OFFICE OF ENVIRONMENTAL SUSTAINABILITY
INSPECTOR'S REPORT ON AN APPLICATION FOR A CERTIFICATE OF AUTHORISATION FOR A CLOSED LANDFILL	
TO:	Dr. Eimear Cotter, Director
FROM:	Ewa Babiarczyk, Inspector, Environmental Licensing Programme
DATE:	11 th August 2020
RE:	Application by Cavan County Council for a Certificate of Authorisation for a closed landfill at Rantavan, Mullagh, County Cavan . Certificate of Authorisation Register Number H0022-01 .

1. Application details

Figure 2: Extent of deposited waste and local surface water network

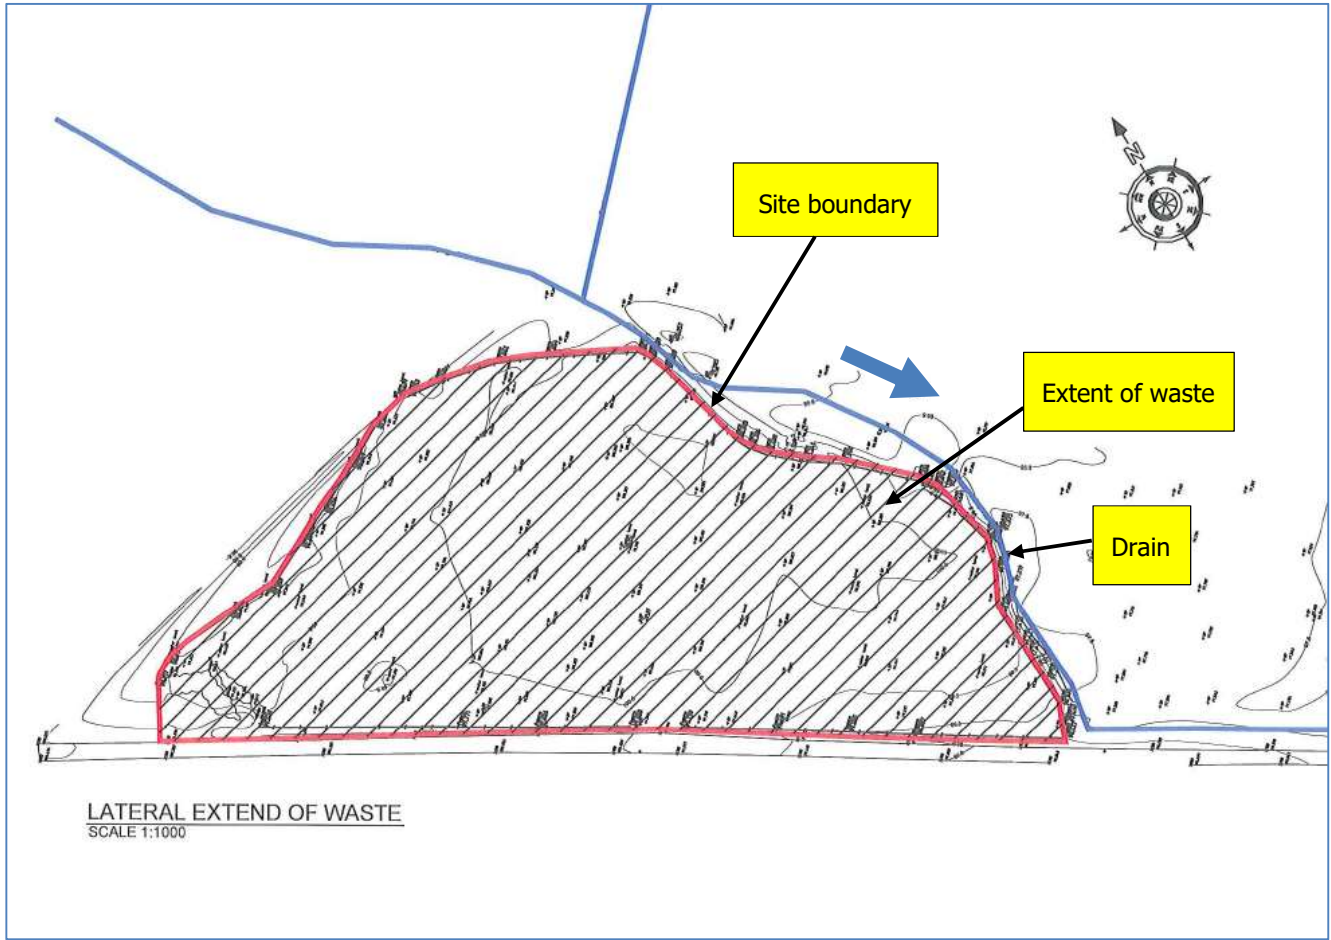
Quantity of waste at the facility	Approximately 18,900 tonnes.
Characterisation of waste deposited	The waste body comprises of municipal waste, construction & demolition (C&D) waste, industrial waste, end-of-life vehicles (ELV), vehicle parts, scrap metal, agricultural waste and hazardous waste such as oils. The deposited waste includes concrete, plastic and glass bottles, empty flattened steel drums, empty plastic drums, concrete pipes, steel, tyres, tyre tubes, wire, glass bottles, paper, timber and trees. There is also stony clay, which the applicant assumes was used as cover material when the site was operational. The extent of the deposited waste is shown in Figure 2.

Figure 4: Groundwater and surface water monitoring locations

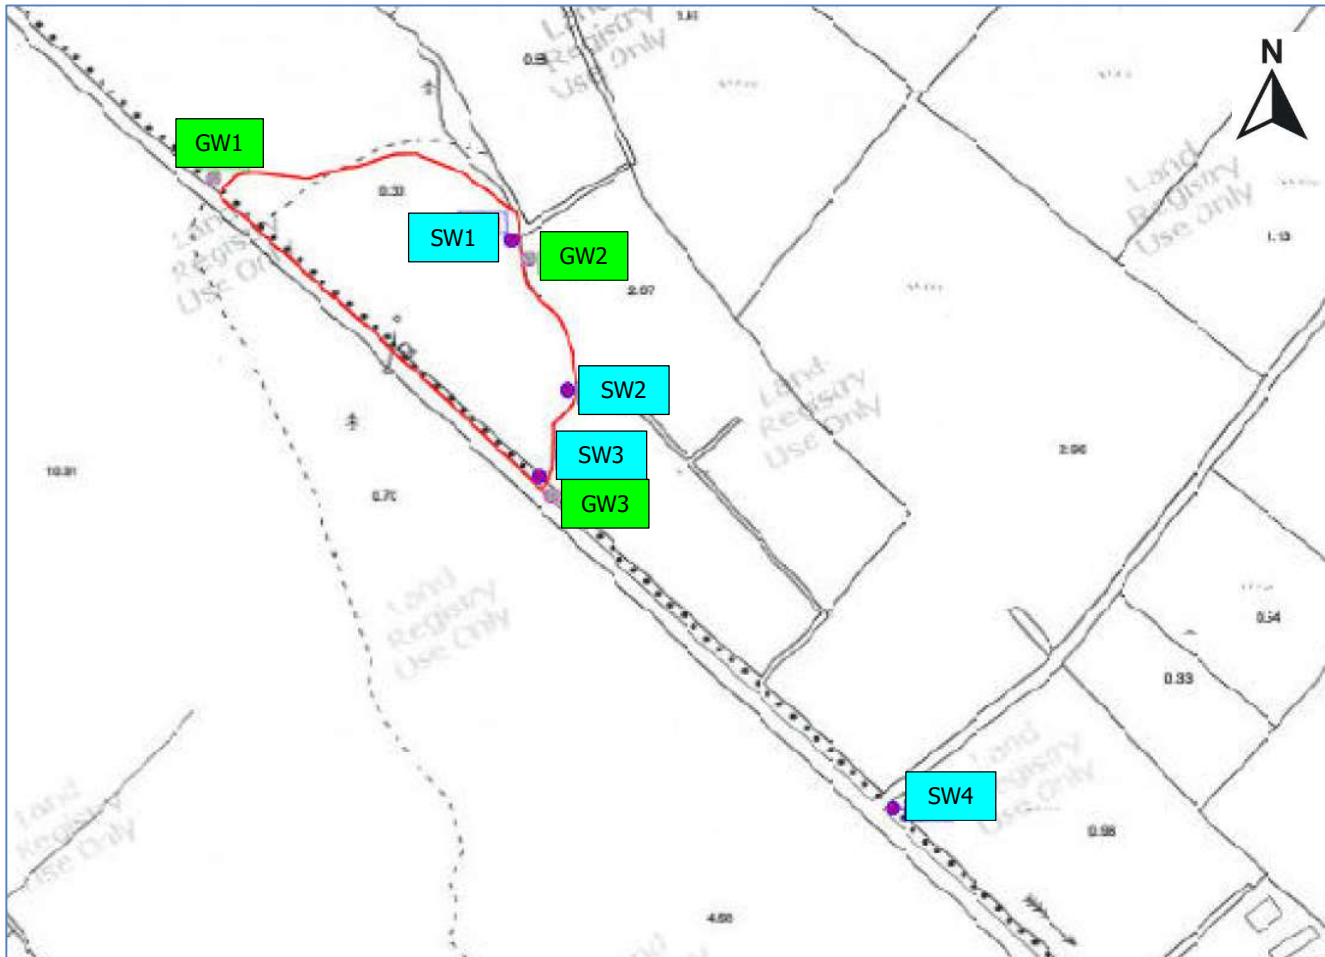
<p>Monitoring and analysis of samples (water, gas, waste):</p>	<p>The most recent groundwater and surface water round of sampling was carried out on 24th September 2019 at the following locations as shown in Figure 4:</p> <ul style="list-style-type: none"> - groundwater sampling: GW1, GW2 and GW3; - surface water sampling: SW1, SW2, SW3 and SW4. <p>Prior to this, the following site investigations were carried out as part of Tier 1 and Tier 2 assessments:</p> <ul style="list-style-type: none"> • site walk-over survey (carried out in 2009); • topographical survey (carried out in 2010); • trial hole survey (one round of sampling was carried out in 2010 at 21 trial holes: TH1 to TH21. Waste was found in TH1 to TH18); • groundwater sampling (one round of sampling was carried out in 2010 at TH3, TH6, TH8, TH11, TH13, TH15 and TH21); • soil sampling (one round of sampling was carried out in 2010 at four locations: TH11, TH13, TH18 and TH21); • gas monitoring (one round of gas monitoring was carried out in 2010 at 8 trial holes GR1 to GR8);

<p>It is noted that the most recent groundwater monitoring event did not include monitoring for copper or zinc. Condition 3.8(e) requires groundwater monitoring to include monitoring for these parameters together with ammonium as N, cyanide, iron, manganese, polyaromatic hydrocarbons and mineral oils.</p> <p>The groundwater monitoring results show that groundwater is contaminated with landfill leachate but other sources, such as agriculture and discharges from septic tanks, also contribute to this contamination.</p> <p>The nearby dwellings are serviced by Bailieborough Public Water Supply (PWS code: 0200PUB1002_1) with the exception of one dwelling which is serviced by a private well located 340m to the east of the closed landfill. Bailieborough Public Water Supply is sourced from Upper Lough Skeagh lake located 16km north of Mullagh therefore, there will be no impact from the closed landfill on the quality of the water which is being abstracted at this water supply. As the groundwater flow is from north-west to south-east and the said private well is located to the east of the landfill, there will be no impact from the closed landfill on this well.</p> <p>There is also a groundwater abstraction located within Wellman International Limited which operates under Licence Reg. No. P0236-01 (Abstraction code: 2300IPC0236_1). This abstraction is located 2.8km north-east of the closed landfill. Given that the groundwater flow is from north-west to south-east, there will be no impact from the closed landfill on the quality of the water which is being abstracted at the licensed site.</p>
